RENESAS TECHNICAL UPDATE

Product Category	MPU/MCU		Document No.	TN-RL*-A087A/E	Rev.	1.00
Title	The usage limitation on RL78/I1C RTC with Independent Power Supply		Information Category	Technical Notification		
Applicable Product	RL78/I1C R5F10Nxx	Lot No.	Reference Document	RL78/I1C User's Manual: Hardware Rev. 2.00 R01UH0587EJ0200 Aug 31, 2018		
		All lots

Figure 1. Problem Judgement Flow for RTC with Independent Power Supply Usage

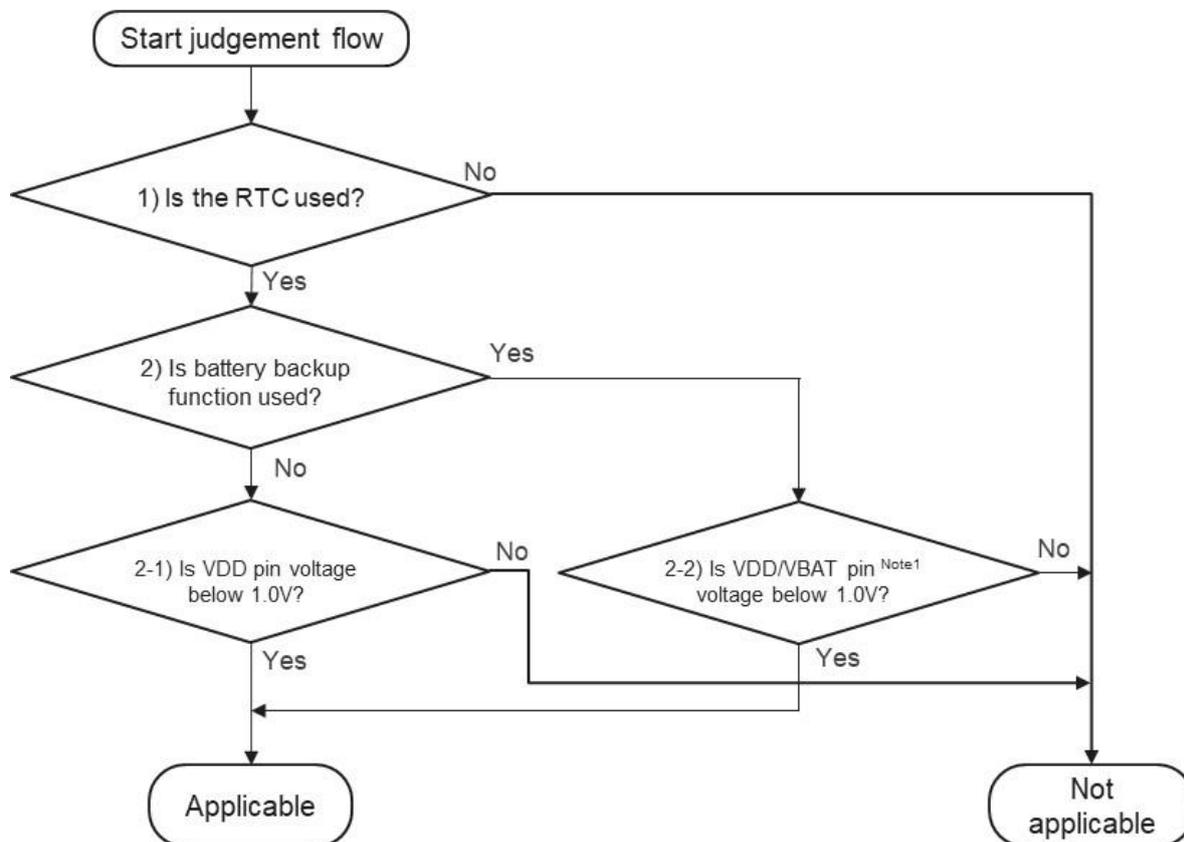
1) If the RTC is not used, the problem is not applicable.

2-1) If the battery backup function is not used (VBATEN=0), and VDD pin voltage is not below 1.0V, the problem is not applicable.

2-2) If the battery backup function is used (VBATEN=1) and VDD/VBAT pin^{Note1} voltage is not below 1.0V, the problem is not applicable.

Figure 2. Problem Phenomenon 1

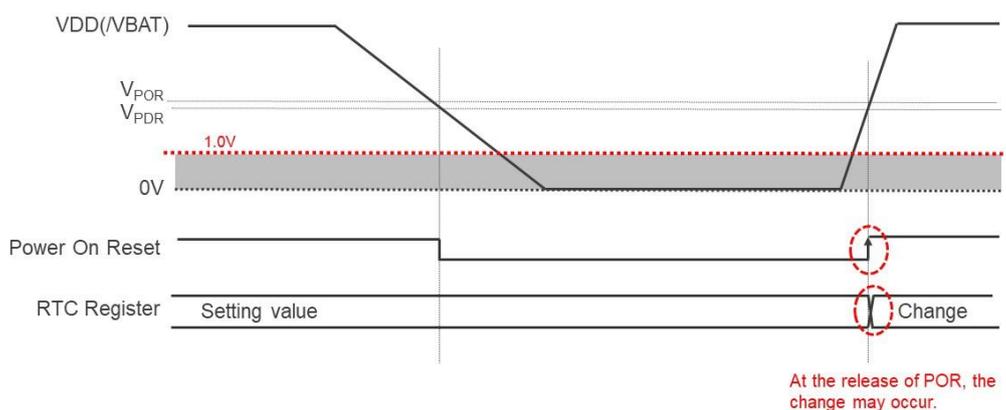
At the release of Power On Reset (POR) during VDD power supply recovery, RTC registers may be changed.

- 1) When the battery backup function is not used, please keep VDD pin voltage always above 1.0V by external power supply circuit.
 For example, by the diode Oring connection, in the case of AC off, VDD pin will be power supplied by the battery.
- 2) When the battery backup function is used, please keep VDD/VBAT pin ^{Note1} voltage always above 1.0V.

Figure 3. Problem Phenomenon 2

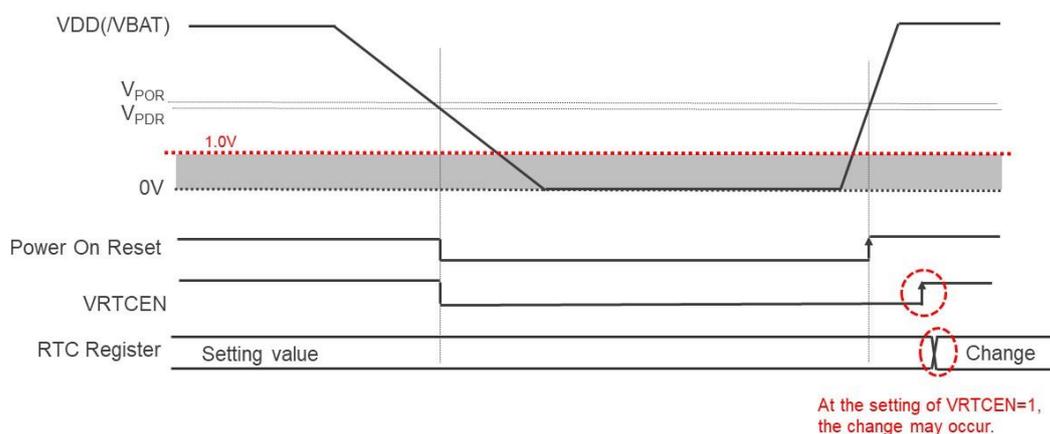
After VDD power supply recovery, at the setting of VRTCEN=1, RTC registers may be changed.

Figure 4. Problem Phenomenon 3

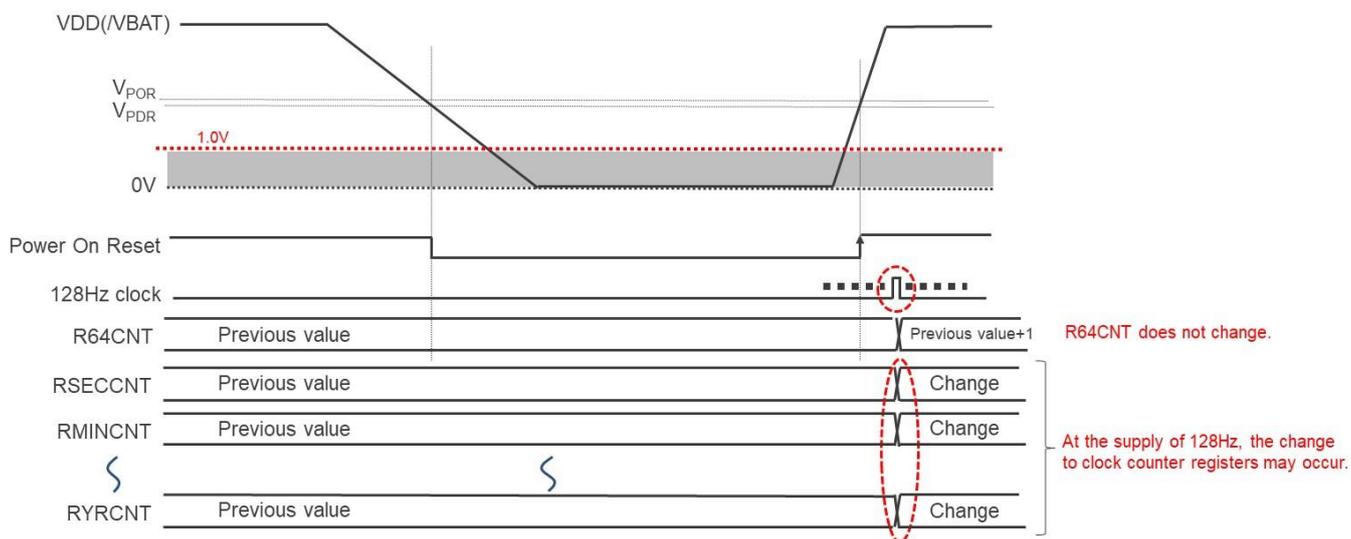
After the release of POR during VDD power supply recovery, at the supply of clock counter 128Hz, except for R64CNT, the other RTC counter registers may be changed.
